Access Compliance Report

Public Rights-of-Way

(Curb Ramps)

Intersection ID: 2754	Main Street: KINGLET_LN	Cross Street: WINGMONT_DR	Location:	E
ADA ID: 7F33529DE379	Ramp Type: PerpDiag	Initial Pass/Fail: Fail	Overall Compliance: No	Severity Score: 12.5
Codes/Mitigation Info/Possible Solution		Field Measurements/Component Compliance

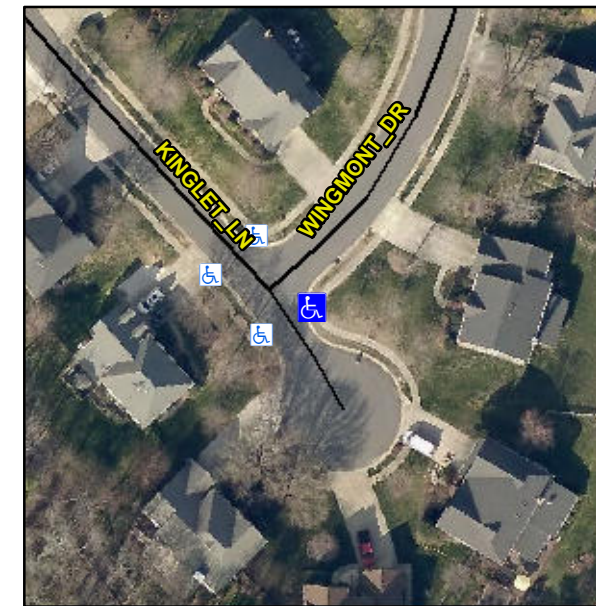
R304.2.2

Compliance	Description	Data	Compliance	Description	Data
N/A	Ramp Length (in)	47.0	No	Ramp Slope (%)	8.9
Yes	Ramp Width (in)	48.0	Yes	Ramp XSlope (%)	1.4
N/A	Flare Type LT	N/A	N/A	Flare Type RT	N/A
N/A	Flare Slope LT (%)	N/A	N/A	Flare Slope RT (%)	N/A
N/A	Flare Traversable LT?	N/A	N/A	Flare Traversable RT?	N/A
N/A	Landing Length (in)	N/A	N/A	DWS Provided?	N/A
N/A	Landing Width (in)	N/A	N/A	DWS Contrast?	N/A
N/A	Landing Slope (%)	N/A	N/A	DWS Length (in)	N/A
N/A	Landing X Slope (%)	N/A	N/A	DWS Full Width?	N/A
N/A	Landing Curb? (Y/N)	N/A	N/A	DWS Offset (in)	N/A
N/A	Shared Landing?	N/A			
N/A	Gutter Ponding?	N/A	N/A	Gutter Slope (%)	N/A
N/A	Gutter Lip Ht (in)	N/A	N/A	Gutter X Slope (%)	N/A
N/A	Painted X Walk1?	No	N/A	Painted X Walk2?	No
	X Walk 1 Direction	To NW		X Walk 2 Direction	To SW
N/A	X Walk 1 Width (in)	N/A	N/A	X Walk 2 Width (in)	N/A
	X Walk 1 Slope (%)	1.7		X Walk 2 Slope (%)	1.4
	X Walk 1 X Slope (%)	1.7		X Walk 2 X Slope (%)	1.2

Remove & Replace Curb Ramp With Two New Directional Ramps or Equivalent.
